<i>Recall Bulletin</i>	<i>RCL-08-005</i>
	<i>DNA</i>

***Subject:* Voltage Regulator**

***Models:* 1098, 1098 S, 1098 TRICOLORE, 1098 R M.Y.'07 AND '08  
848 M.Y.'08 AND '09**

**Recall Bulletin RCL-08-005 Voltage Regulator**

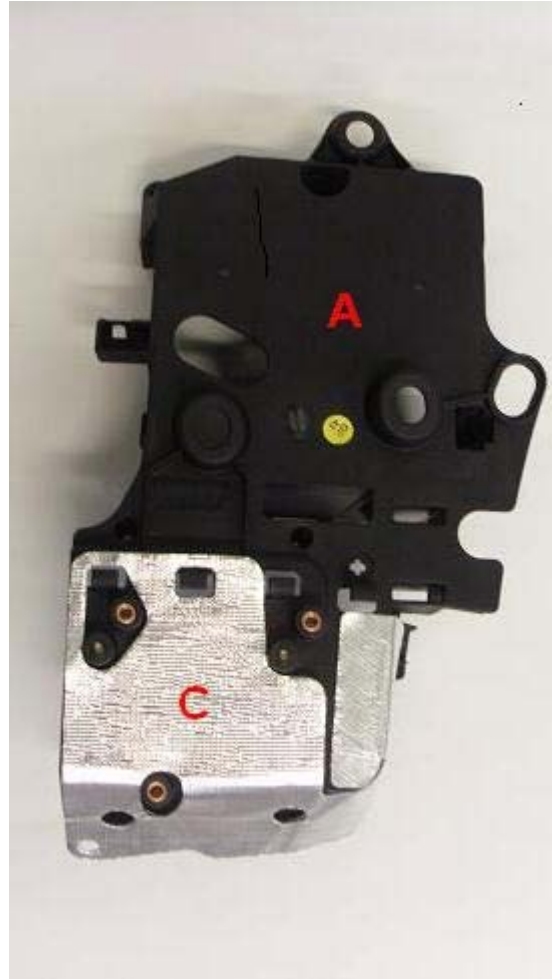
Assemble kit components no. 69924371A below and the voltage regulator

A) Battery support

B) Heat guard

C) Battery compartment protection

D) Voltage regulator

E) Screws M 6 x 10

F) Screws M 6 x 22

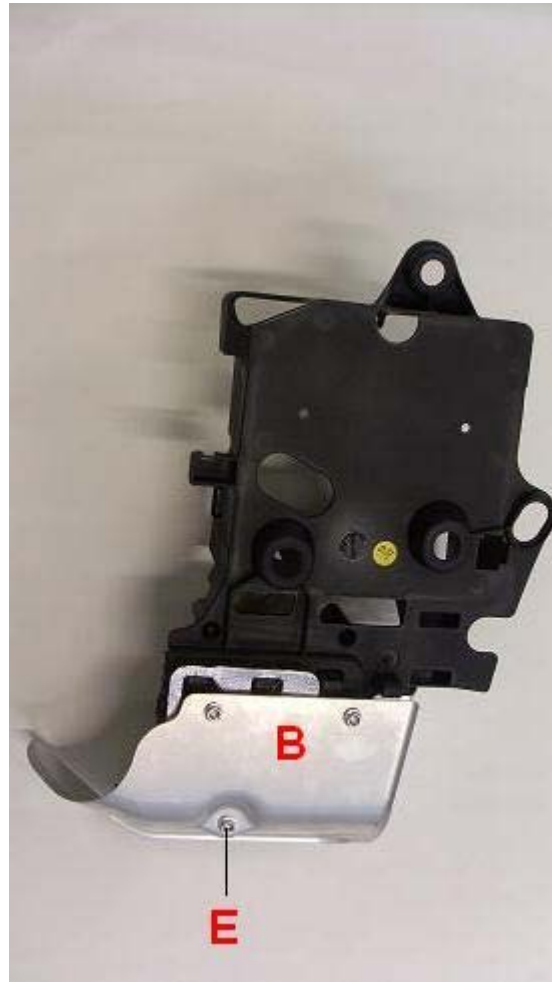
Install the adhesive protection C on the battery support A as shown in the picture.

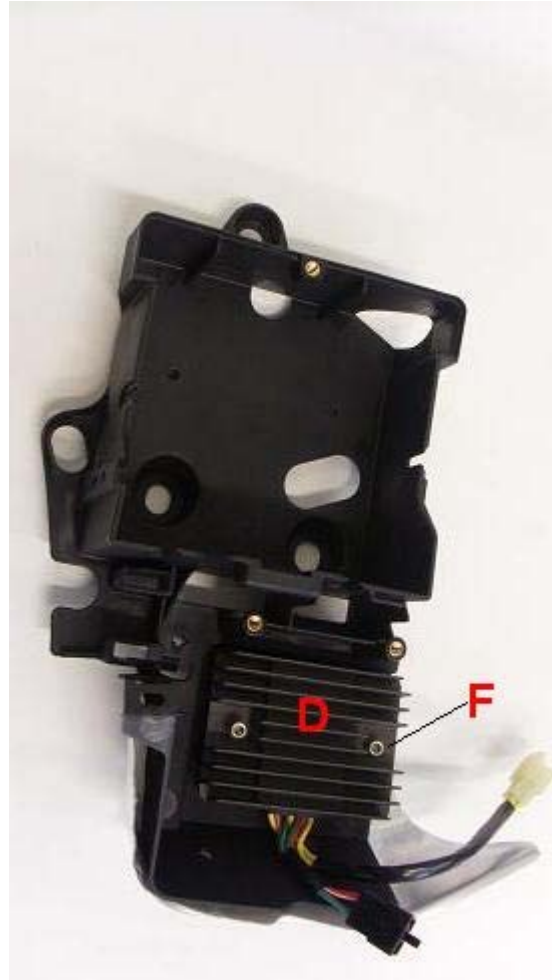
Install the heat guard B on the battery support using the three screws E
